REVISED TECHNICAL SPECIFICATIONS

AFFECTED PAGES

(1) CORPORATE REORGANIZATION  
REVISED TS PAGES

H. B. ROBINSON UNIT #2  
Caroline Power & Light Company

**FACILITY ORGANIZATION**  
**ROBINSON NUCLEAR PROJECT**  
Figure 6.2-2

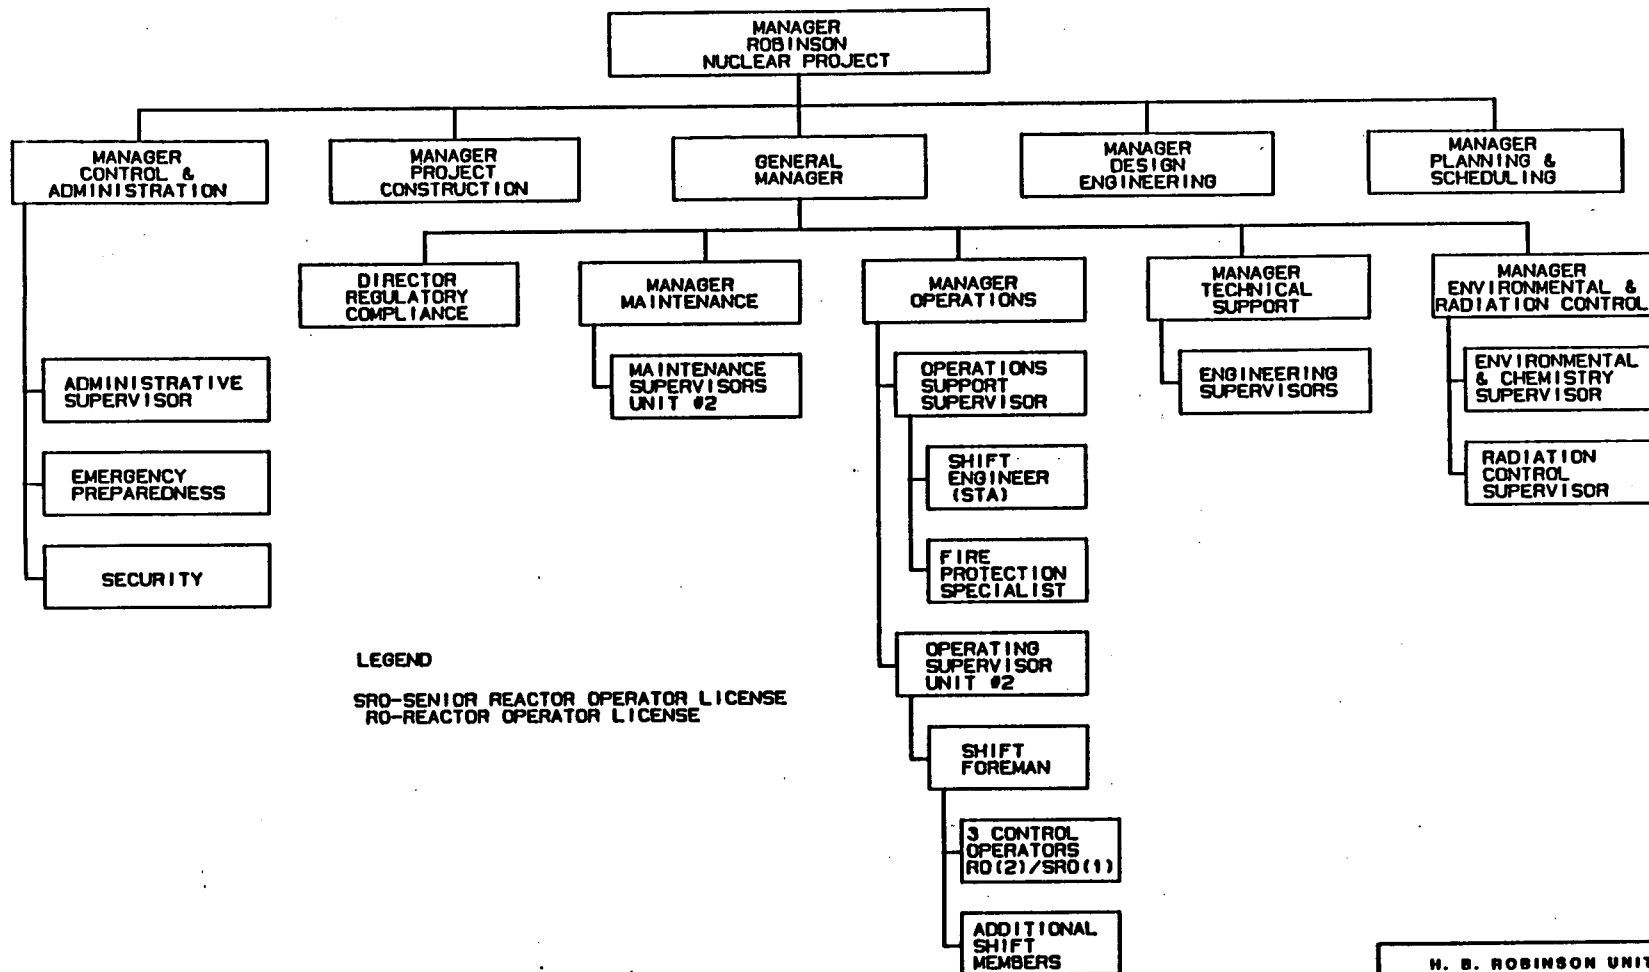
- 6.2.3 The Robinson Nuclear Project organization shall be as shown in Figure 6.2-2 and:

(2) POSITION TITLE CHANGE

REVISED TS PAGE
